ATTACHMENT 1 TO NL-11-118

**Response to Request for Additional Information
(HOLTEC NON PROPRIETARY)**

Entergy Nuclear Operations, Inc.
Indian Point Units 2 and 3
Docket Nos. 50-247 and 50-286

REQUEST FOR ADDITIONAL INFORMATION (RAI) REGARDING SPENT FUEL TRANSFER ENTERGY NUCLEAR OPERATIONS, INC. INDIAN POINT NUCLEAR GENERATING UNIT NOS. 2 AND 3 DOCKET NOS. 50-247 AND 50-286

Figure 8-2.1: STC Confinement Boundary Welds

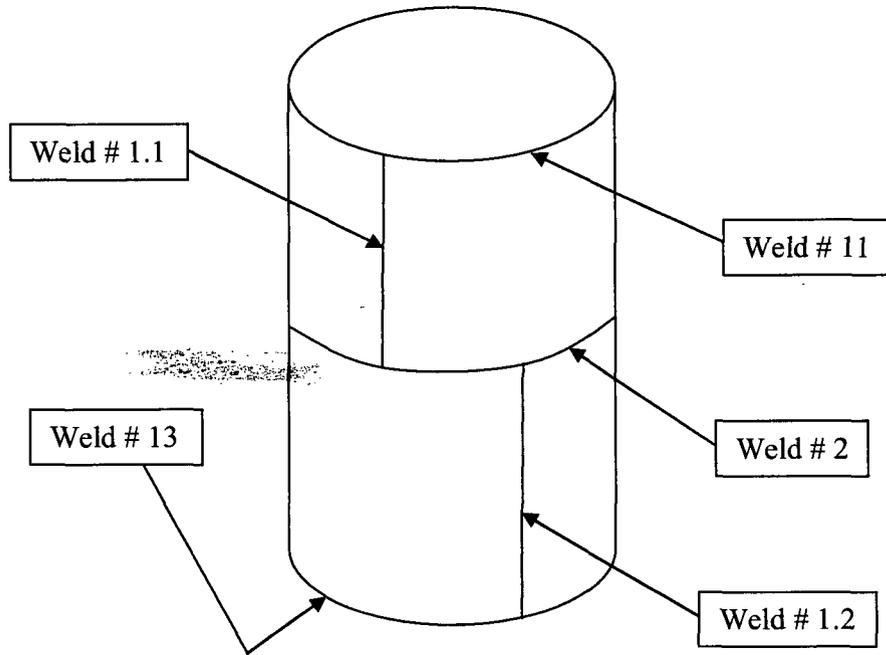
ASME Code Subsection NC requires full radiography of the weld joints. However, select radiography is required by ASME Code Subsection ND. Substantiate the justification provided previously for the limited radiographic testing (RT). Provide evidence that the portions of the confinement boundary welds that were not subject to RT will perform as expected. Include a discussion of weld repairs that resulted from RT over adjacent and similar joint configurations. Alternatively, perform full radiography of the weld joints as required by ASME Code Subsection NC. (SMMB)

Spent fuel canisters are normally constructed to ASME Code Subsection NB or NC. The licensee is proposing to construct the STC to ASME Code Subsection ND and has provided a table outlining the discrepancies between Subsection NC and ND. However, discrepancies regarding both brittle material behavior and weld quality were not adequately addressed.

From Table 8-2.1, four of the five STC confinement boundary welds have been subjected to 100% radiography as ASME Code Subsection NC would require. Overall 79% of the total weld length associated with the STC confinement boundary welds have been examined by RT. The only portions of the STC confinement boundary welds that have not been fully radiographed with acceptable results are the shell-to-upper flange weld, a 1" segment of the shell-to-base plate weld that has a known indication and was not repaired, and a 1" segment of the shell-to-base plate weld that was repaired after RT, but was not re-examined. A non-conformance report was generated for the two 1" segments on the shell-to-base plate weld, and the discrepant conditions were evaluated against ASME Code Subsection ND requirements and accepted as-is (Ref. Holtec SMDR # 1775-2008).

In summary, the STC confinement welds have been subject to an extensive amount of RT examination, which far exceeds the minimum requirements of ASME Code Subsection ND.

In fact, the longitudinal and circumferential welds within the STC shell have been fully radiographed such that they meet the inspection requirements of ASME Code Subsections NC and ND. It is only the shell-to-upper flange weld and limited portions of the shell-to-base plate weld that have not been subject to 100% RT per ASME Code Subsection NC.

Figure TS-1.1

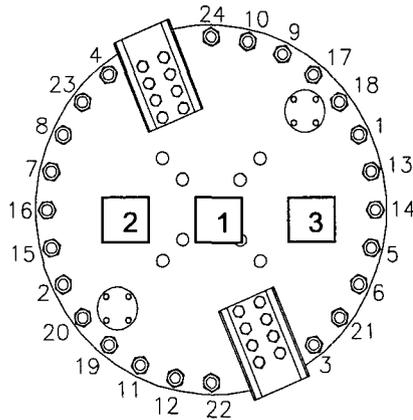
Modify proposed TS Appendix C, Part II, 5.4.2 and 5.4.6 to provide dose rate limits and associated measurements that are appropriate for the allowable loading configurations and are supported by the evaluations in the licensing report (SAR). (CSDAB)

In a letter dated July 28, 2011, in response to RAI TS-4 the applicant proposed dose rate limits and associated measurements for the transfer operations. The dose rate limits are for the STC lid and the side of the HI-TRAC. However, the proposed limit and measurements for the STC lid do not appear to be adequate for the operations. The limit for the STC lid and its measurement were derived from a configuration with the STC fully loaded and the air gap present in the STC. The description in the operations section of the SAR has the measurement performed with the STC filled with borated water. Also, given that the inner basket cells may be kept empty to comply with criticality requirements, it is not clear that the single measurement location at the STC lid radial center is sufficient. Additional measurement locations should be specified that include areas over the outer basket cells.

In response to the RAI request for additional measurement locations on the STC lid Entergy proposes to take two additional verification measurements approximately 180 degrees apart and 12 to 18 inches from the center of the lid, avoiding the areas around the inlet and outlet ports, to ensure that the lid surface dose rate in this location also does not exceed the proposed TS limit. All measurements required by the TS shall be taken when the STC is in the HI-TRAC after the steam space is established and prior to HI-TRAC lid installation.

“The dose rate measurement shall be taken at the approximate center of the STC top lid. Two (2) additional measurements shall be taken on the STC lid approximately 180 degrees apart and 12 to 18 inches from the center of the lid, avoiding the areas around the inlet and outlet ports. The measurements must be taken when the STC is in the HI-TRAC after the steam space is established and prior to HI-TRAC lid installation.”

As illustrated below, the dose rate measurements will be taken at locations 1, 2, and 3.
